# Proposed Browse to NWS Development

## Proposal Content Document

<b>Proposal title</b>	Proposed Browse to NWS Development (State component)
<b>Proponent name</b>	Woodside Energy Ltd, as Operator for and on behalf of the Browse Joint Venture
<b>Short description</b>	Drilling and completion, subsea installation, commissioning, operation, inspection, maintenance and repair and decommissioning of subsea wells and associated subsea infrastructure located in Western Australian State waters, to extract hydrocarbons from the Torosa reservoir, located approximately 425 km north of Broome and approximately 290 km off the Kimberley coast.

**Figure 1 – Proposed Revised State Proposal Area (yellow).**

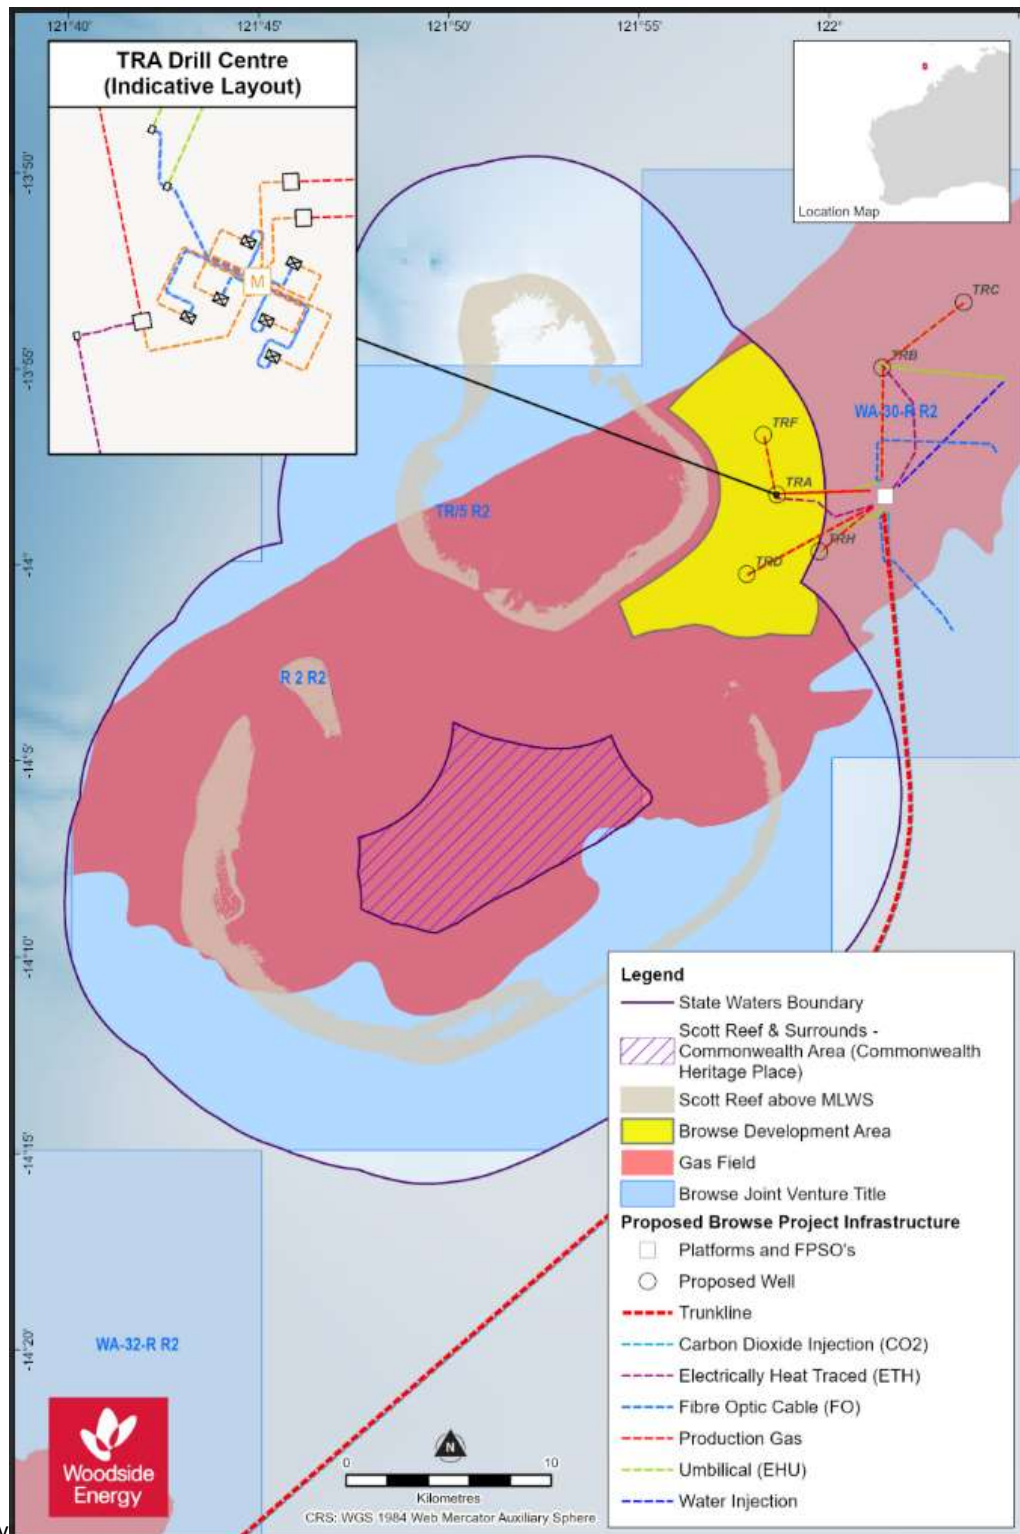
Proposal element	Location / description	Maximum extent, capacity or range (as of 12 October 2022)	Proposed Amendment	Revised extent, capacity or range
Physical elements				
Petroleum production wells	Installation and physical presence of infrastructure within indicative field layout as per Figure 1 below.	Up to 0.24 km <sup>2</sup> of direct seabed disturbance (including 25% contingency).  Up to 20 wells.	<b>Relocating the “TRD” drill centre.</b>  <b>Reduce development envelope (maximum area within which the physical elements occur) as per Figure 2 below.</b>	Up to 0.24 km <sup>2</sup> of direct seabed disturbance (including 25% contingency).  Up to 20 wells.  <b>No drill centre within 20 km of Sandy Islet.</b>  <b>All physical elements to be installed within a Development Envelope of 78 km<sup>2</sup>.</b>
Operation & maintenance of subsea infrastructure (e.g. wells, flowlines, and umbilicals)
